HISTORIC AND DESIGN REVIEW COMMISSION

July 20, 2016

HDRC CASE NO: 2016-265
ADDRESS: 419 DONALDSON AVE
LEGAL DESCRIPTION: NCB 6695 BLK 4 LOT 5
ZONING: R6 H
CITY COUNCIL DIST.: 7
DISTRICT: Monticello Park Historic District
APPLICANT: Ronald Catlett
OWNER: Raul Ruiz
REQUEST:

FRONT ELEVATION

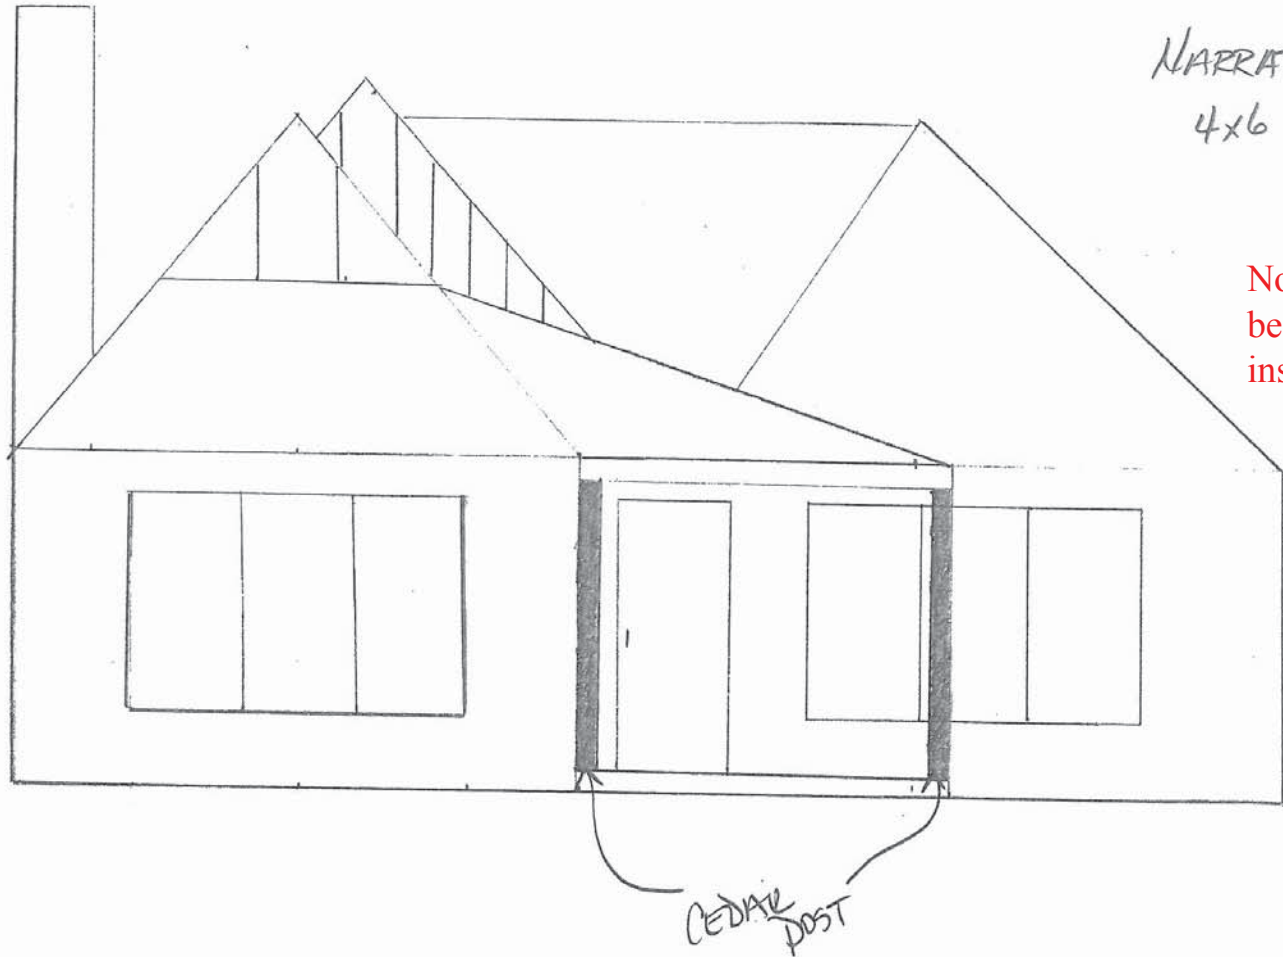
- a. The home at 419 Donaldson Ave is in the Monticello Park Historic District, designated March 23, 1995. The home is a Tudor with stone facades.
- b. Existing, the front porch has a concrete floor with one corner wrought iron decorative post. The applicant is proposing to remove the wrought iron post and install three 4"x6" cedar posts, two along the front and the other along the side of the porch. According to the Guidelines for Exterior Maintenance and Alteration 7.B.v., porch elements should be based on the architectural style of the building. Staff finds cedar posts and configuration appropriate for the Tudor style house, thus consistent with the Guidelines.

NARRATIVE
4x6 CEDAR POST

No other modifications are
being requested beyond
installing the cedar posts

NORTH ELEVATION
419 DONALDSON AVE

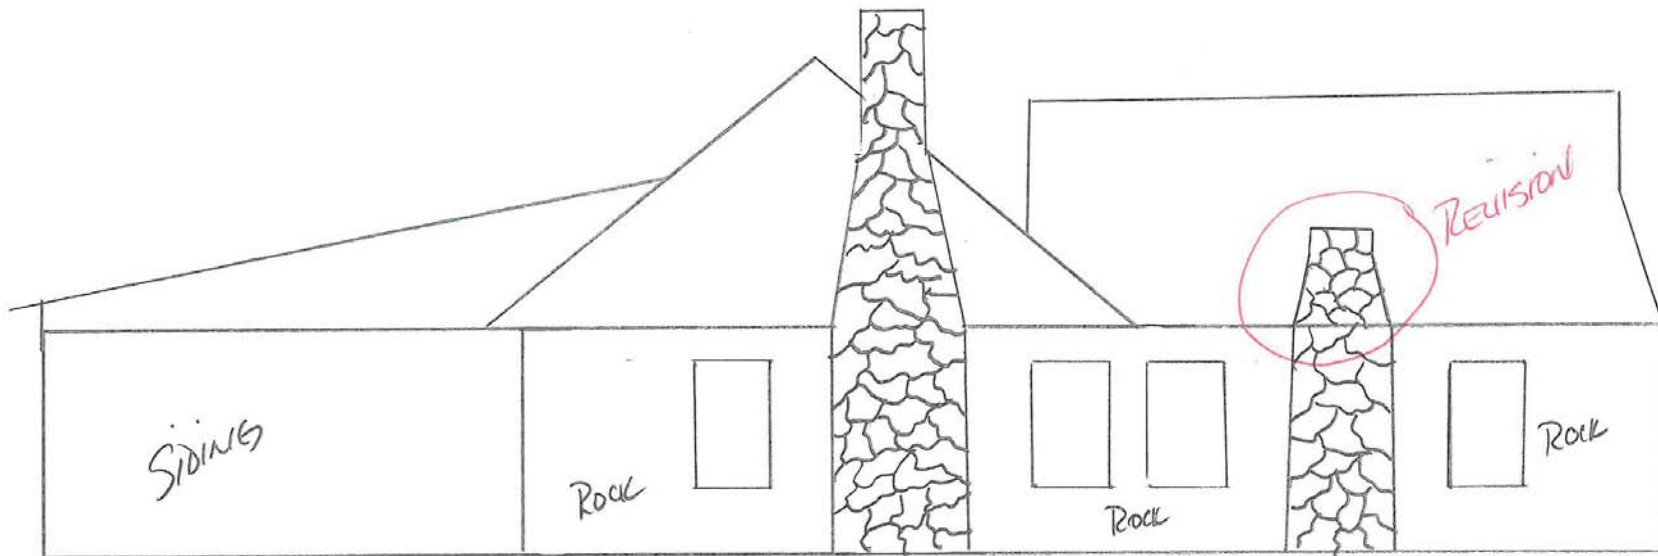
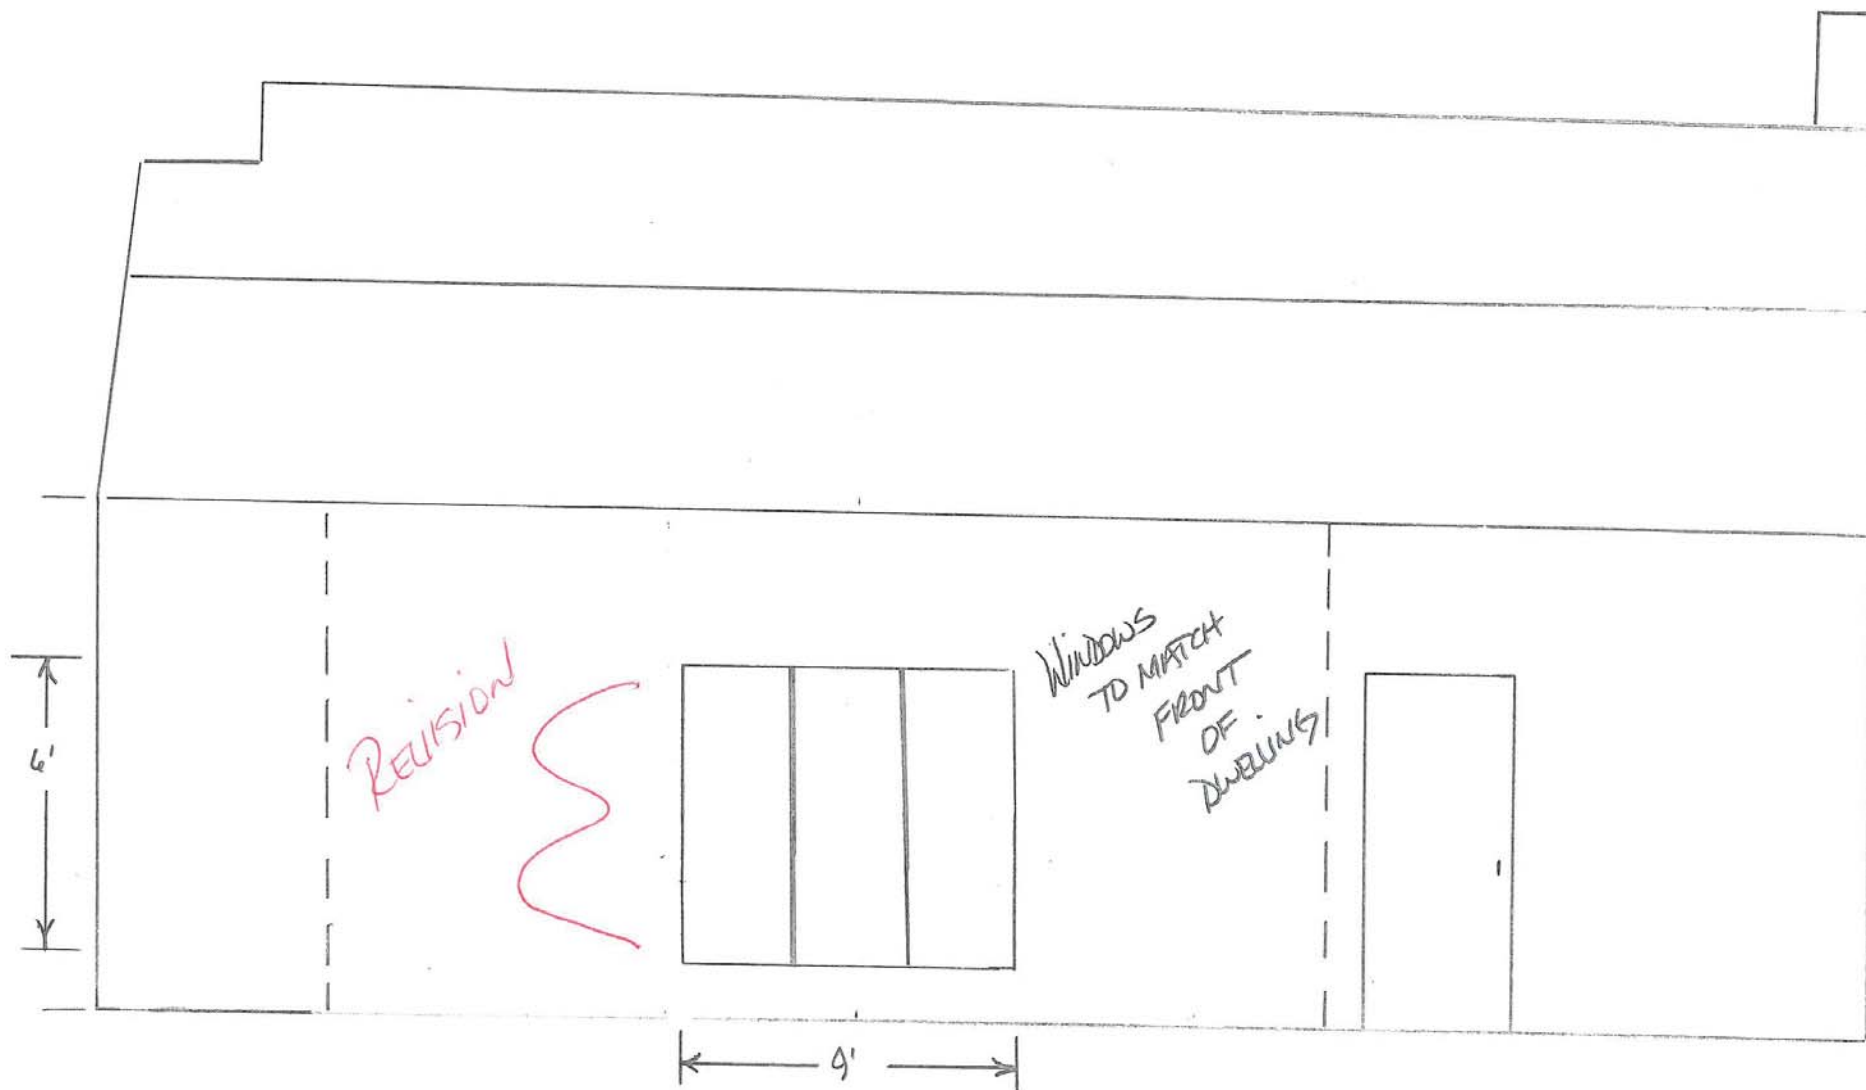
- d. There is an existing aluminum fixed window on the rear façade of the addition. The windows on the front and side facades are aluminum one over one with wood screens. The applicant is proposing to remove the rear window and install a triple window with 3 one over one aluminum windows. According to the Guidelines for Exterior Maintenance and Alterations, windows should match the proportion of those existing. Staff finds the existing opening non-original and finds the removal and replacement triple windows consistent with the Guidelines.

- e. When repairing the foundation, the chimney at the front left elevation collapsed. The collapsed chimney is an exterior chimney on the left façade that matched a secondary chimney on the same façade in height, material and design. The applicant is not proposing to rebuild the chimney at this time but is proposing to cap the collapsed chimney above the roof line. Staff finds the chimney an architectural defining feature. If the chimney cannot be rebuilt, staff finds capping the chimney appropriate. Staff also finds the method of capping above the roof line appropriate as indicates the presence of the chimney.

Proposed chimney cap

Triple, aluminum one over one windows to match front windows on main structure

1. That the windows feature clear glass, and be inset 2 inches.
2. That the applicant provide measurements and details of the chimney cap.
3. That chimney be capped with the help of a professional to ensure that the masonry units are not damaged in the process and that the applicant use mortar that matches the original in color, profile and composition.

BACK ELEVATION

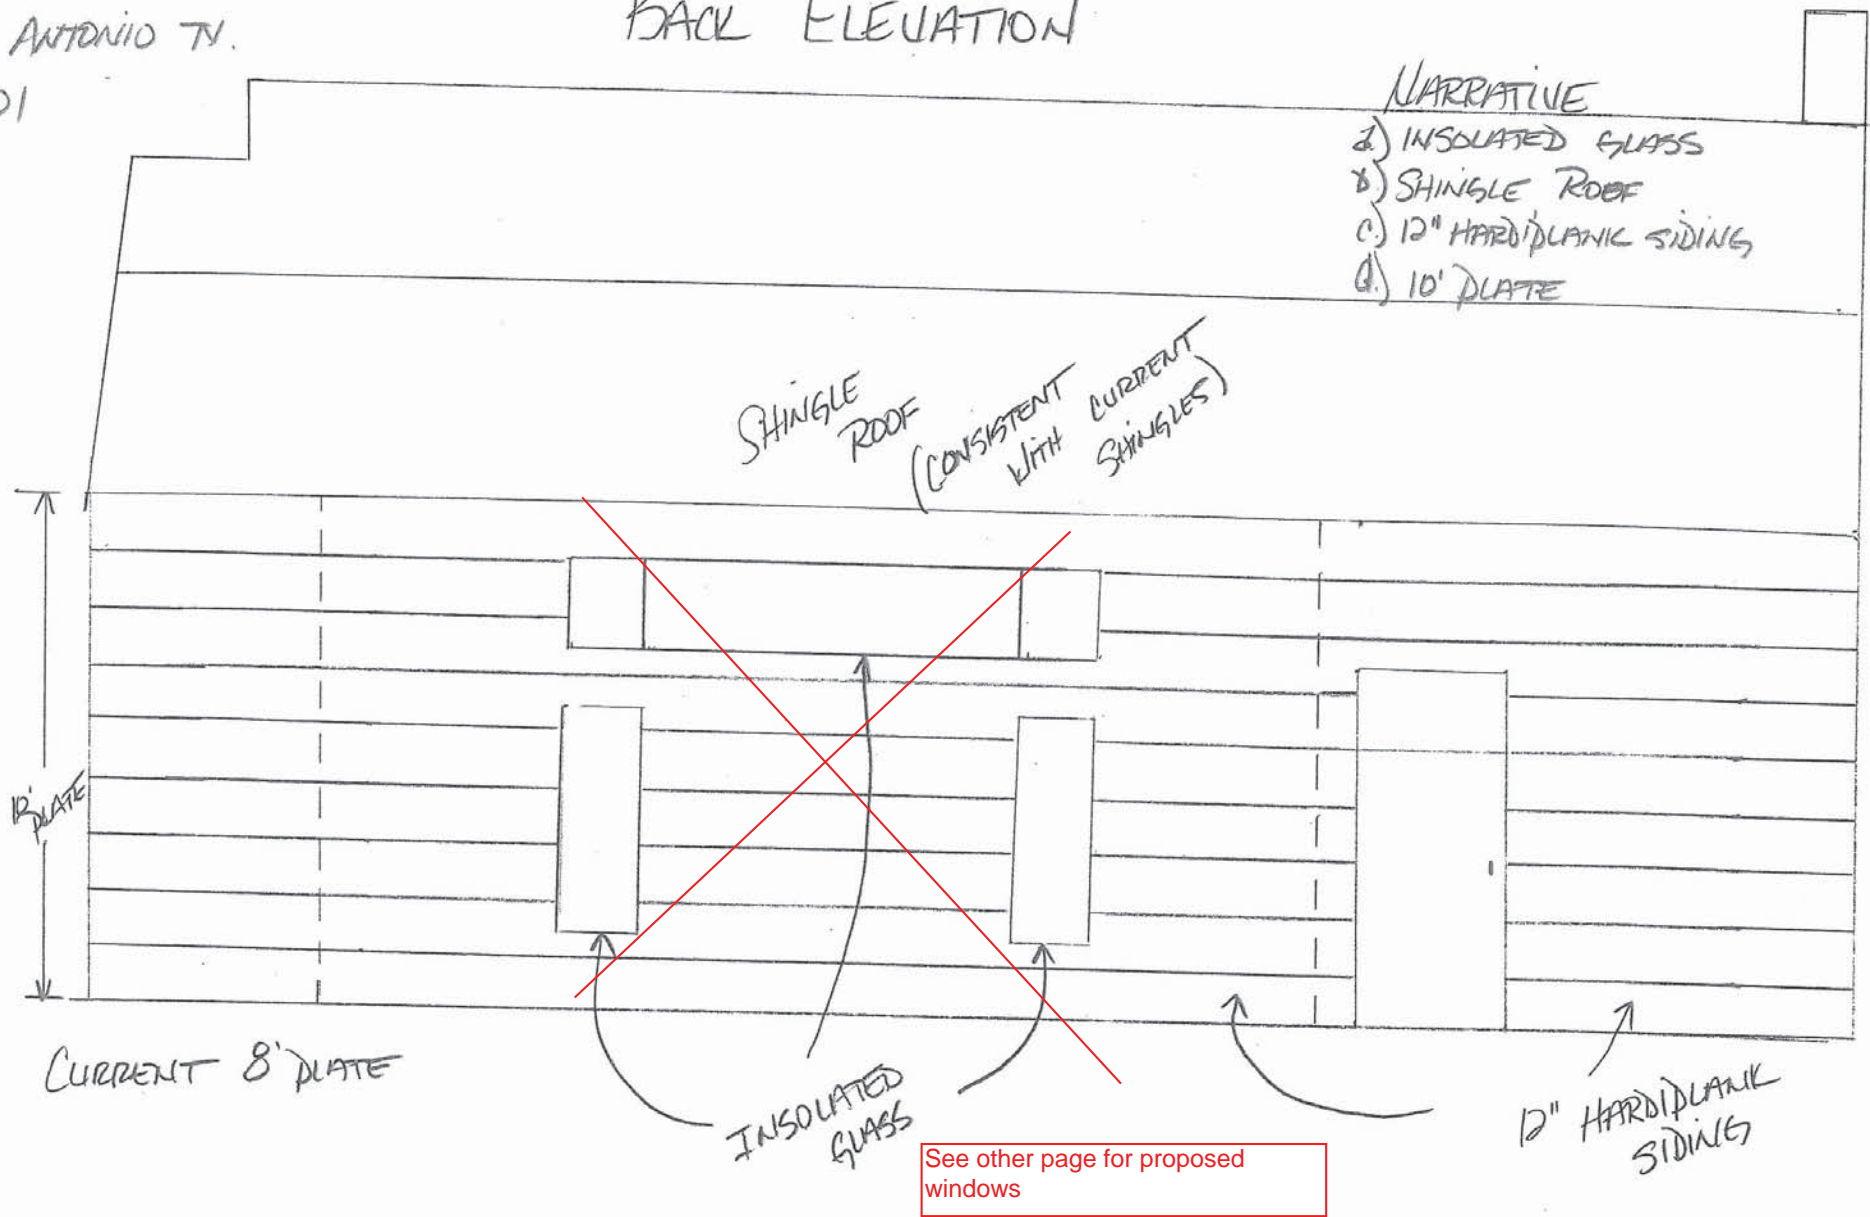
- c. Existing, there is a rear addition with a shed roof with an 8' plate. The applicant is proposing to increase the slope of the shed roof line and increase the height of the addition façade to 10' without altering the square footage and installing composition shingles to match existing. According to the Guidelines for Additions 1.A.i., additions should not be seen from the public right of way. Staff finds the increased height of the shed roof is not visible from the right of way and is consistent with the Guidelines.

- NARRATIVE
- a) INSULATED GLASS
 - b) SHINGLE ROOF
 - c) 12" HARDPLANK SIDING
 - d) 10' PLATE
